PLAN AND PROFILE OF PROPOSED STATE HIGHWAY

FEDERAL AID PROJECT NO. CRP-0024-04(031) CRP-0024-04(032) CRP-0024-04(033)

SR 15/SR 16 ROUNDABOUT NESHOBA COUNTY

REVISION

DATE 12:55:37 PM TITLE_SH.dgn

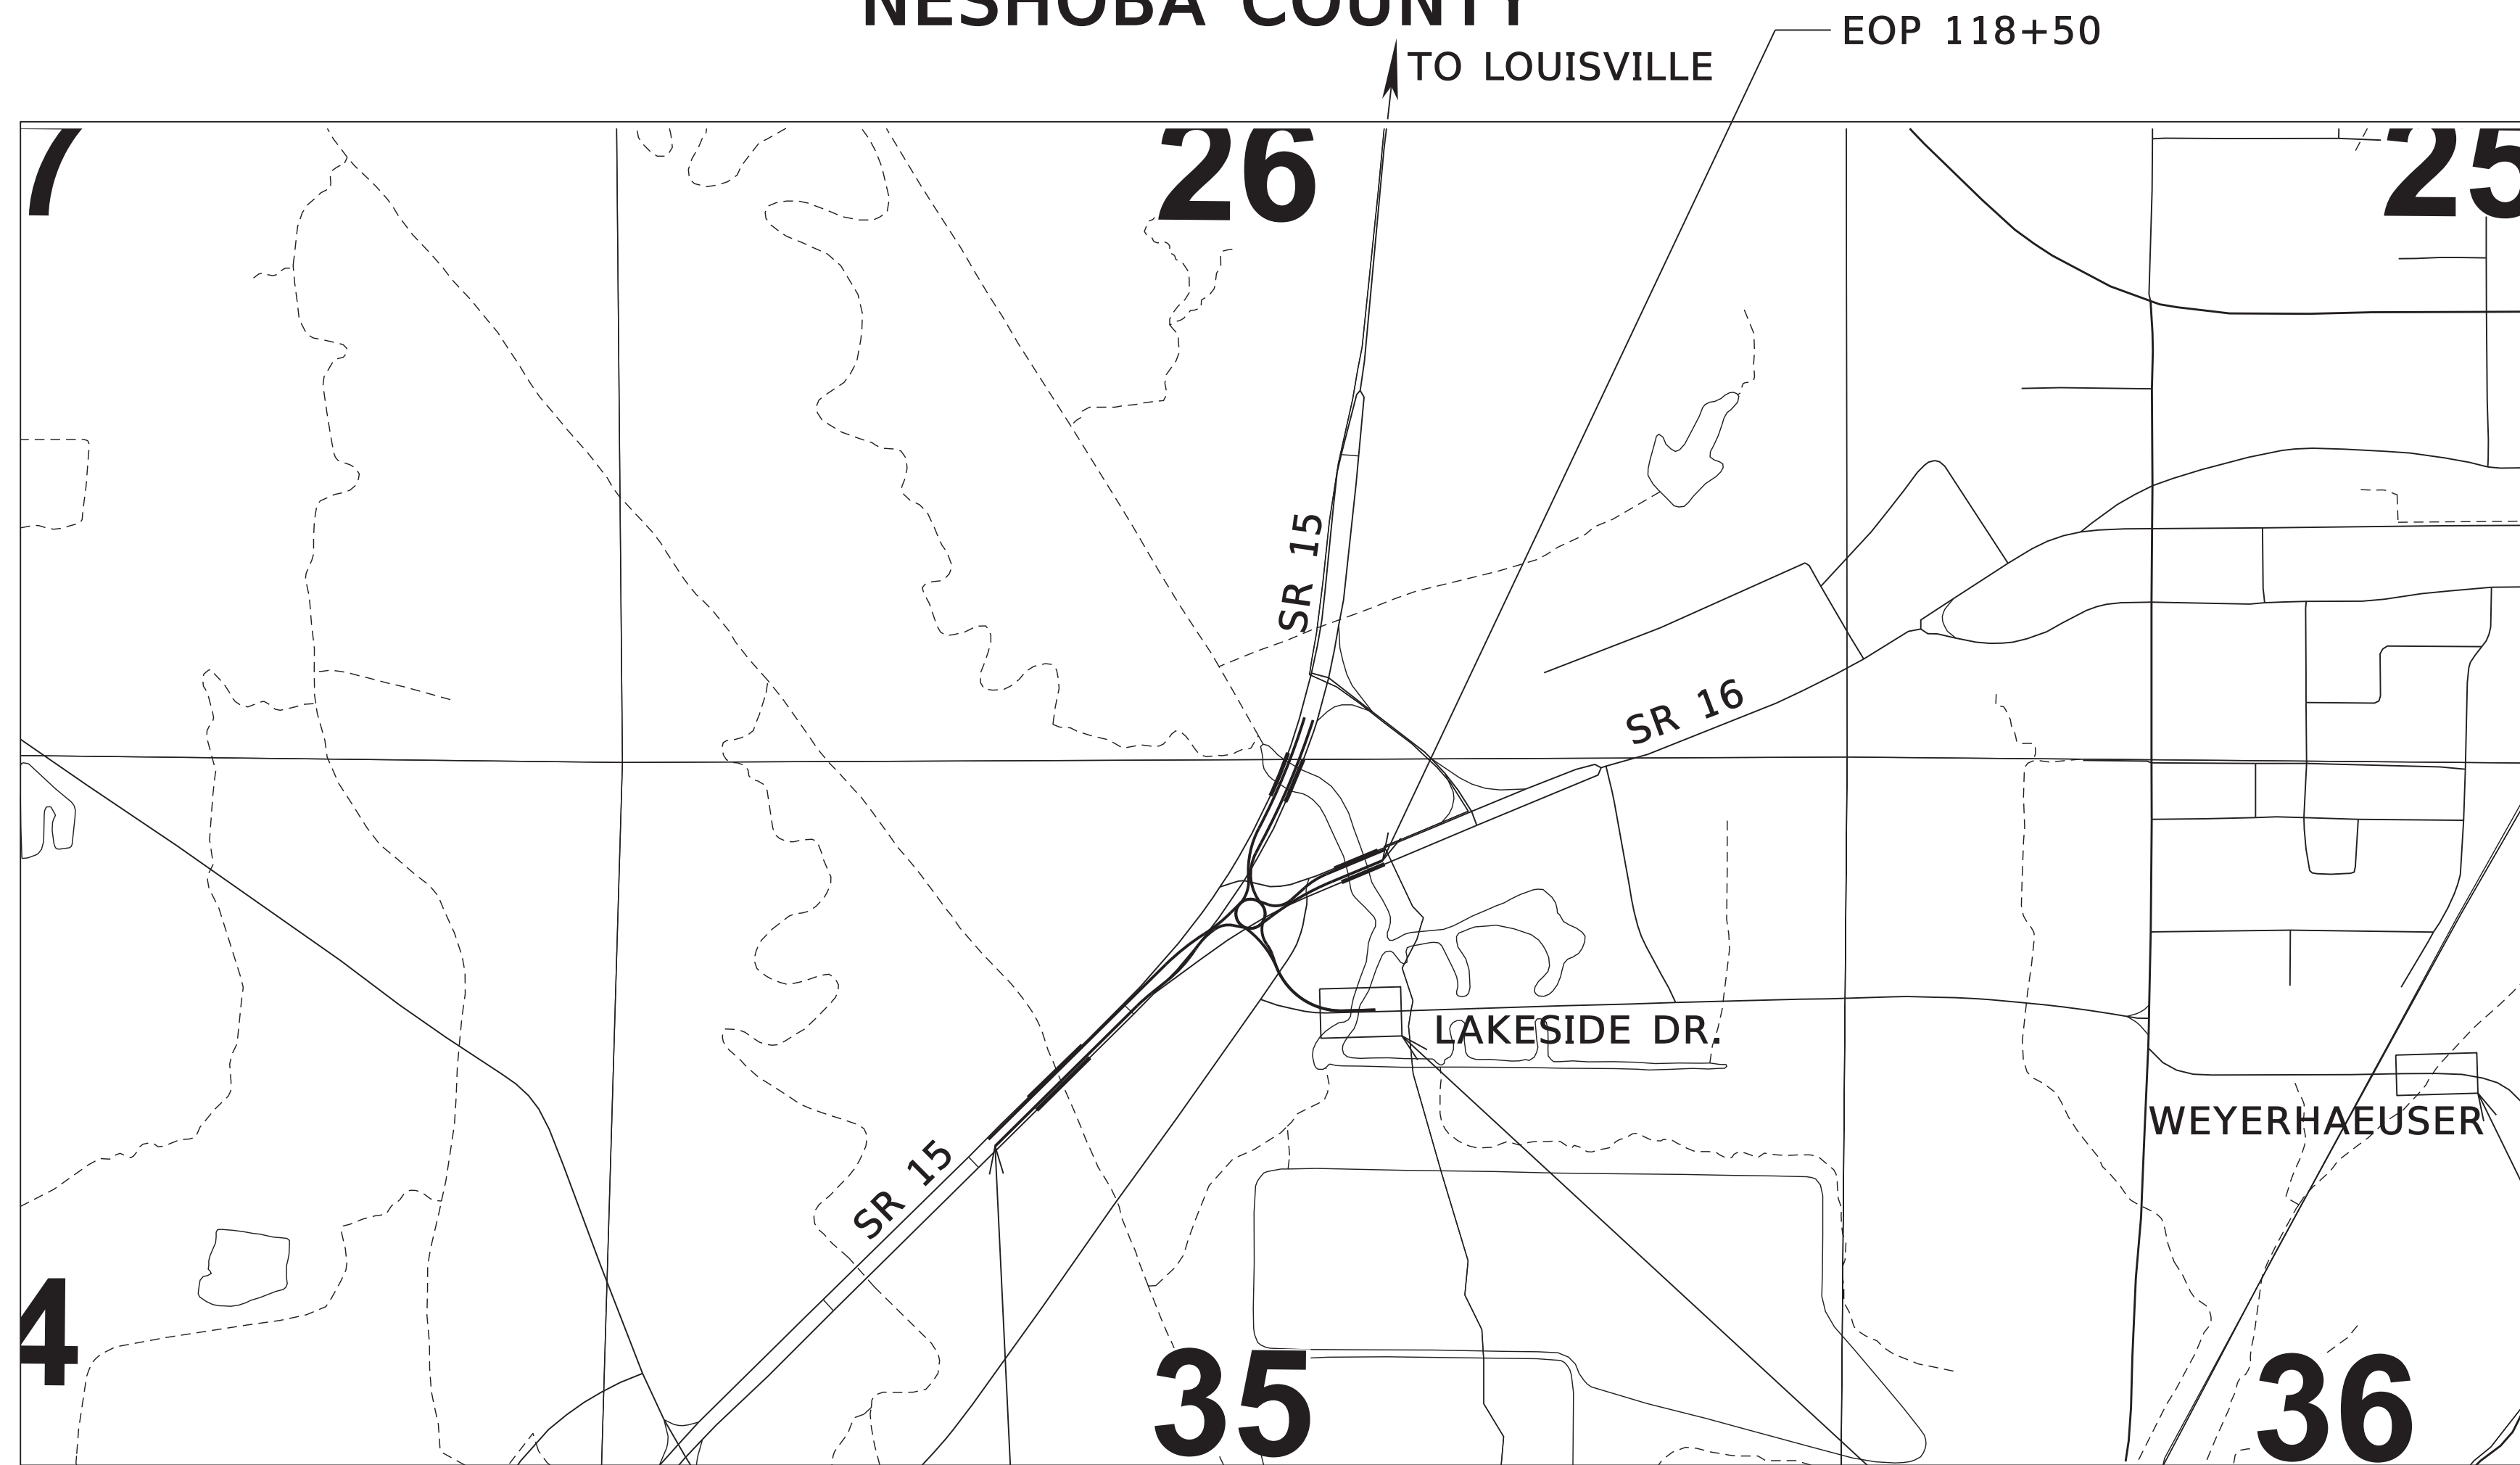
SUMMARY OF REVISIONS						
DATE	1st ORDER	ADDENDUM	2nd ORDER	BY	SHEET ID	DESCRIPTION
11-12-24	X			VOLKERT	TITLE	STORMWATER PERMIT UPDATED.
11-12-24	X			VOLKERT	SQ-1	UPDATED GRASSING QUANTITY.
11-12-24	X			VOLKERT	SQ-2	UPDATED GRASSING QUANTITY.
11-12-24	X			VOLKERT	SQ-3	UPDATED GRASSING QUANTITY.
11-12-24	X			VOLKERT	SQ-4	UPDATED GRASSING QUANTITY.
11-12-24	X			VOLKERT	SQ-5	UPDATED GRASSING QUANTITY.
11-12-24	X			VOLKERT	SQ-6	UPDATED GRASSING QUANTITY.
11-12-24	X			VOLKERT	SQ-7	UPDATED GRASSING QUANTITY.
11-12-24	X			VOLKERT	SQ-8	UPDATED GRASSING QUANTITY.
11-12-24	X			VOLKERT	SQ-9	UPDATED GRASSING QUANTITY.
11-12-24	X			VOLKERT	SQ-10	UPDATED GRASSING QUANTITY.
11-12-24	X			VOLKERT	SQ-11	UPDATED GRASSING QUANTITY.
